City of **HOBART**

APPLICATION UNDER SULLIVANS COVE PLANNING SCHEME 1997

Type of Report: Committee
Council: 6 August 2018
Expiry Date: 5 September 2018
Application No: PLN-18-368
Address: 1 - 3 ELIZABETH STREET , HOBART
3 MORRISON STREET , HOBART
Applicant: (JMG Engineers and Planners)
117 Harrington Street
Proposal: Signage
Representations: Nil
Performance criteria: Signs Schedule

Figure 3: the proposed sign at 1-3 Elizabeth Street.

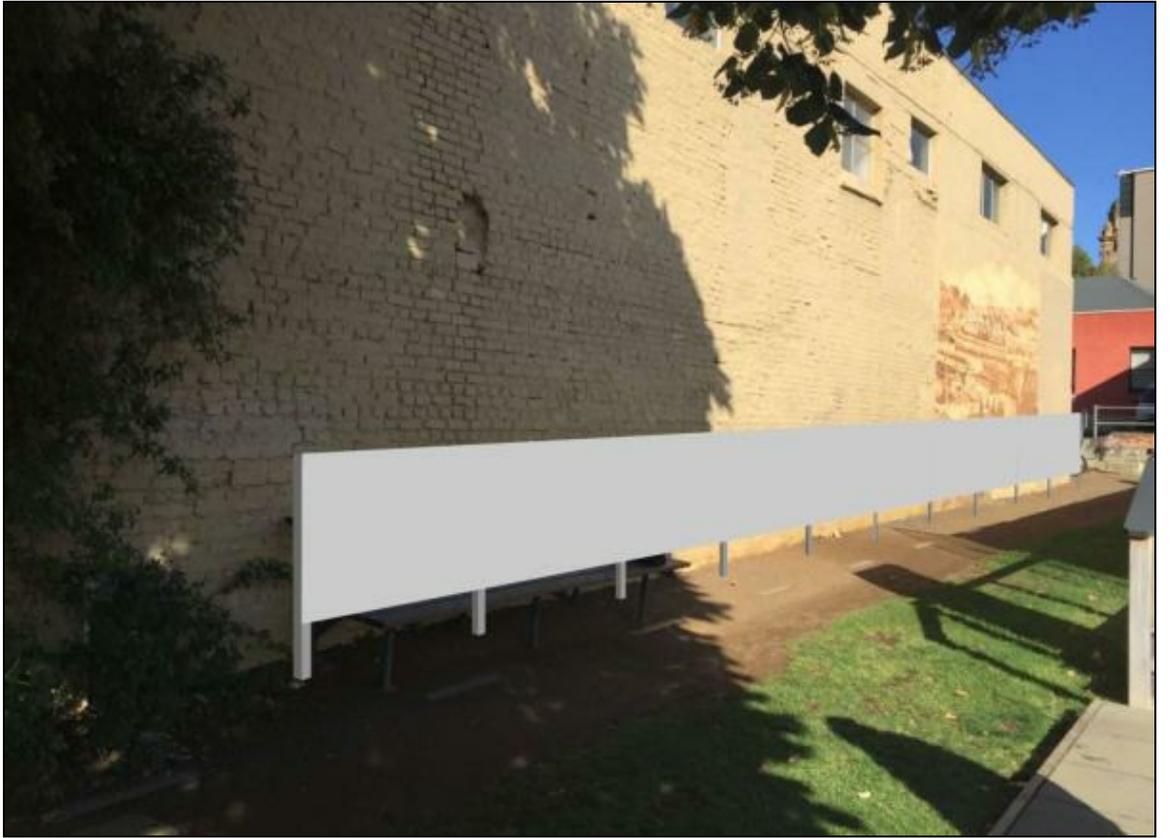
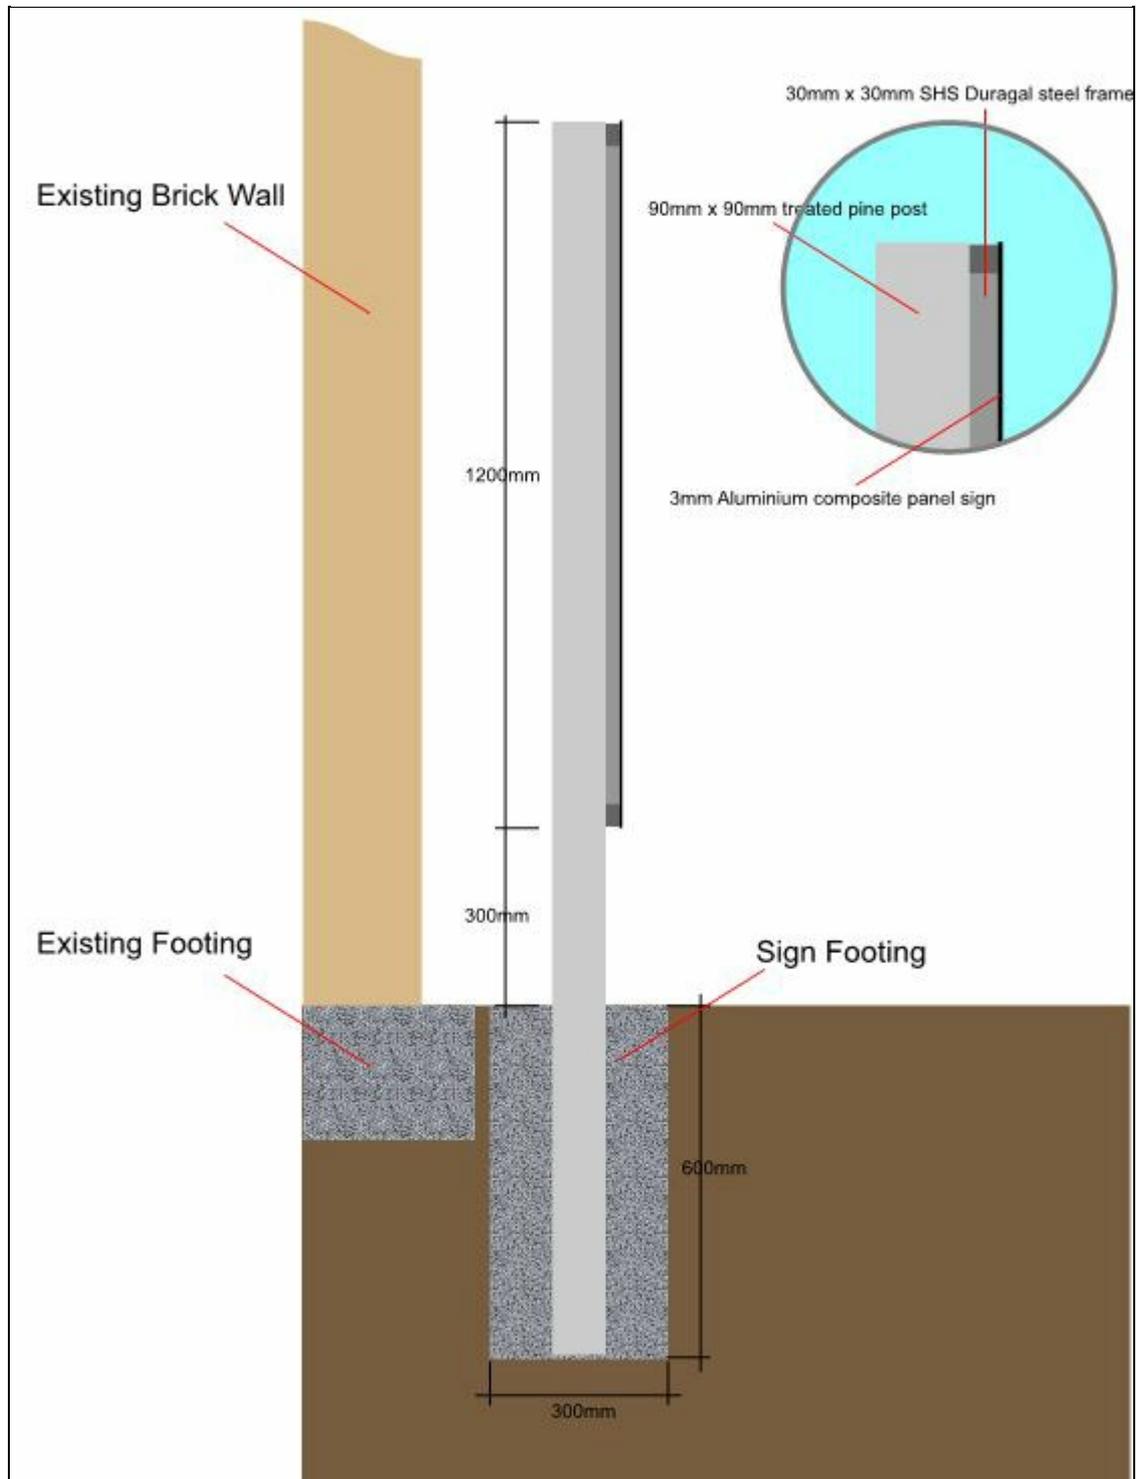
- 6.7.3 The proposed sign would extend along the length of the building beside the walkway beside Mawson's Hut. It is considered that this would not appear dominant on the streetscape as it would be partially obscured by Mawson's Hut and would blend in with the wall of the building behind. The Council's Cultural Heritage Officer has assessed the impact of the sign on the cultural significance of the place under clause 6.7.6 of this report below.

6.7.5 There are a number of existing signs on the site associated with Mawson's Hut. As such, there is the potential for the site to become cluttered with signs. However it is considered that the size, type and location of the proposed sign, would not create unreasonable clutter of signage or visual disorder. This is because the sign would appear to merge with the wall of the building behind and would be partially hidden by Mawson's Hut. The sign would not impact on the safety or security of the premises and as the walkway would remain usable to the public, would not be detrimental to pedestrian movement or safety. The sign would not be beside the road and because of the one-way direction of traffic, would generally not be visible to vehicles on the road, as such it is considered that there would be no detrimental impact on the safety of the road.

The proposed interpretive sign will provide information about Hobart's Antarctic heritage and connections, and is suitably placed adjacent to the temporary replica museum structure. The site has a number of other signs and paraphernalia and care should be taken to minimise this clutter in the longer term.

The applicant has consulted with Council officers regarding the sign content, and was advised that the text should concentrate on Antarctic connections rather than attempting to address broader cultural and historical themes.

The sign is only approved while the Mawson's Hut Replica Museum use is in operation. The sign must be removed within three months of that use ceasing to operate.
